NOTICE OF VIOLATION

On October 3, 2024, Energy Safety conducted an inspection of SDG&E's WMP initiatives in the vicinity of the city of Jamul. The inspection report is enclosed herewith. Energy Safety found the following violation:

INSPECTION REPORT

Item1IA1mg1: Vegetation within the 10-foot radius of the pole. The photo was taken from Sage Mountain Lane.

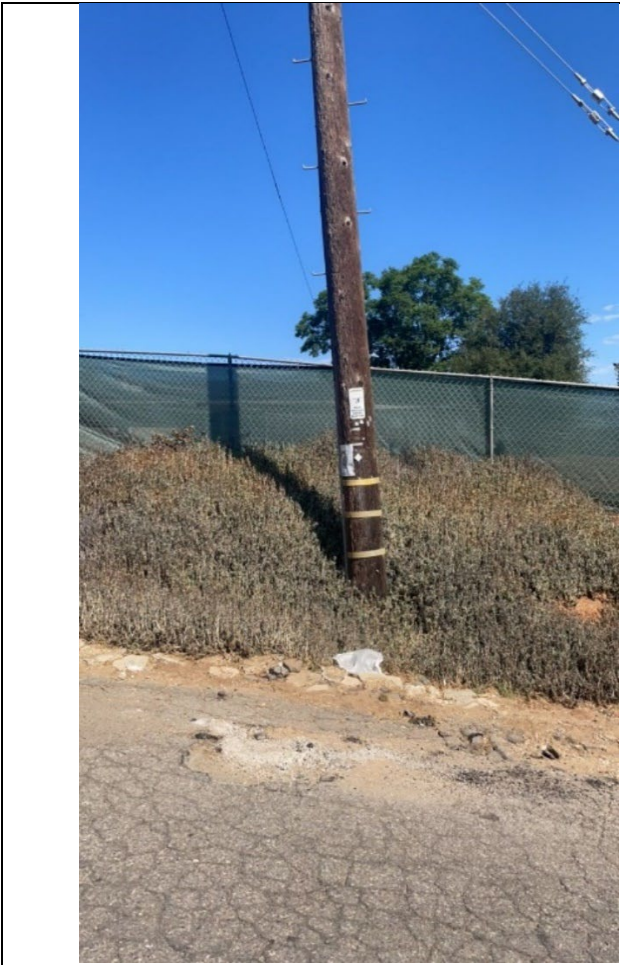
The reported location provided by SDG&E indicated that work for the Pole Clearing program (.512 WMP initiative number 8.2.3.1) was reported as completed. At pole 775836 located along Sage Mountain Lane in Jamul at GPS coordinates 32.713864, -116.887710, the inspector observed that vegetation (ice plant, *Malephora crocea*) was growing within a 10-foot radius from the subject pole. SDG&E's Q2 QDR data indicated the pole was mechanically cleared in April 2024. The inspector's observation is documented in Violation 1 photographs, which are exhibits to this report. Photo number Item1IA1Img1 shows vegetation within a 10-foot radius of the pole and Item1IA1Img2 shows the pole ID. Photo number Item1A1Img3 shows the vegetation that lies within the 10-foot radius of the pole from a closer perspective.

Energy Safety concludes that Violation 1 is "Moderate" because the vegetation fuel bed consists of light flashy fuels in the form of desiccated vegetation.

SDG&E's WMP states the following regarding initiative number 8.2.3.1 Pole Clearing: "Mechanical pole brushing is the clearing all vegetation around the base of a pole down to bare mineral soil for a radius of 10 feet from the outer circumference of the pole; removing all live vegetation within the cylinder up to a height of 8 feet above ground; and removing all dead vegetation up to the height of the conductors. Mechanical brushing is typically performed in the spring months."⁷
